Salem Nuclear Generating Station, Unit No. 1 and Unit No. 2
Facility Operating License Nos. DPR-70 and DPR-75
NRC Docket Nos. 50-272 and 50-311

Subject: Response to NRC Request for Additional Information, dated October 25, 2010, related to Structures Monitoring associated with the Salem Nuclear Generating Station, Units 1 and 2 License Renewal Application

**Response to Request for Additional Information regarding the Spent Fuel Building
Structure associated with the Salem Nuclear Generating Station, Units 1 and 2 License
Renewal Application**

RAI B.2.1.33-07

Section from UFSAR Fig. 3.6-26

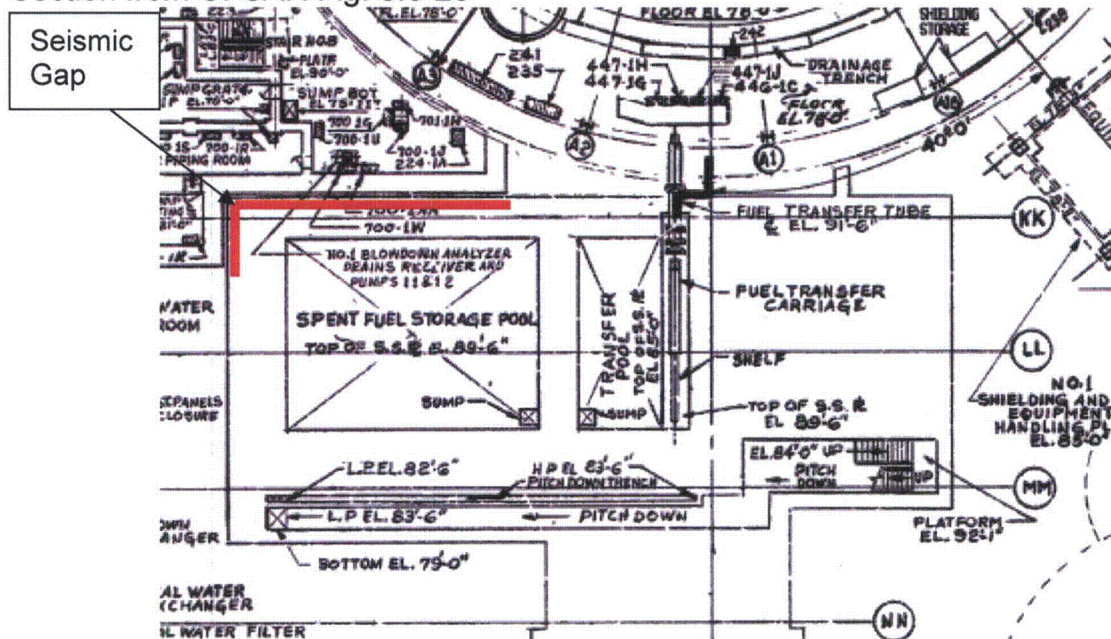
Although the applicant has stated that there are no indications of active leakage through the accessible SFP wall, the applicant has not confirmed that there is no through-wall leakage from the three inaccessible walls of the SFP.

Provide information to confirm the claim that there is no active through-wall leakage from the SFP occurring in any of the SFP walls, including the inaccessible walls.

3. The leakage path of the Spent Fuel Pool water.
1. For clarification, there is a small amount of leakage believed to be at the construction joint at the bottom of the Spent Fuel Pool east wall adjacent to the Auxiliary Building. Refer to UFSAR figure 3.6-26 (portion attached) for the plant configuration as it relates to the following discussion.

- There is a small amount of leakage at the east wall construction joint as evidenced by grab samples at the seismic gap drain, which exhibit short-lived isotopes. This wall is 6' thick. The wall at the seismic gap is not accessible below grade. It is believed that the leakage is along the construction joint at the bottom of the wall (Elevation 89-foot), similar to what was observed at the west wall before the telltale drains were cleared in 2003. The leakage rate from the Unit 1 Spent Fuel Pool at the construction joint at the bottom of the east wall is estimated to be about 1/8 of a gallon per day from the SFP, as evidenced by seismic gap drain leakage and the associated sampling.

- The west wall of the Fuel Handling Building is accessible below grade, where the telltale drains allow leakage flow to the sump. This wall is 9'-7" thick. No evidence of through-wall leakage has been visually observed since clearing of the telltale drains in 2003 allowed for drainage of water trapped behind the Spent Fuel Pool liner.

- Leakage through the south wall is considered to be impossible due to the thickness of the wall south of the transfer pool, which is approximately 39' thick. This wall is not accessible below grade.

- Based upon samples from the monitoring wells in the yard area north and west of the Fuel Handling Building, there is no indication of through-wall leakage from the north wall. This wall is 8'-9" thick, and is not accessible below grade. The monitoring well system and the specific monitoring wells outside of the north west corner of the Fuel Handling Building and at the west end of the Fuel Handling Building do not exhibit any increasing trend of radionuclides (tritium). In addition, the monitoring well closest to the northwest corner of the Spent Fuel Pool exhibits lower levels of tritium than the monitoring well west of the Fuel Handling Building, which would not be the case if there was through-wall leakage at the north wall of the Fuel Handling Building.

2. The seismic gap drain was installed in the Salem Unit 1 Auxiliary Building in 2004 at approximately 9 feet below the construction joint in the Fuel Handling Building, adjacent to the bottom of the east wall of the Spent Fuel Pool. The seismic gap drain was installed to remove water from the seismic gap between the Fuel Handling Building and the adjacent Auxiliary Building, providing a path for any water entering the gap to be captured by the plant radioactive waste system. Thus, the seismic gap drain prevents release of radioactivity to the environment. The leakage of Spent Fuel Pool water into the Fuel Handling Building seismic gap drain is addressed in the Environmental portion of the LRA in Section 2.3. The seismic gap drain is continuously open to maintain a hydraulic gradient flowing into the Auxiliary Building and prevent any environmental release. The water samples from the seismic gap drains have detected some short-lived radionuclides. Monitoring wells installed in the Groundwater Recovery System are routinely monitored to develop trends in tritium concentration and verify no new source materials are released to the environment. Refer to the attached figure for a cross section through the Fuel Handling Building, which provides relative elevations.
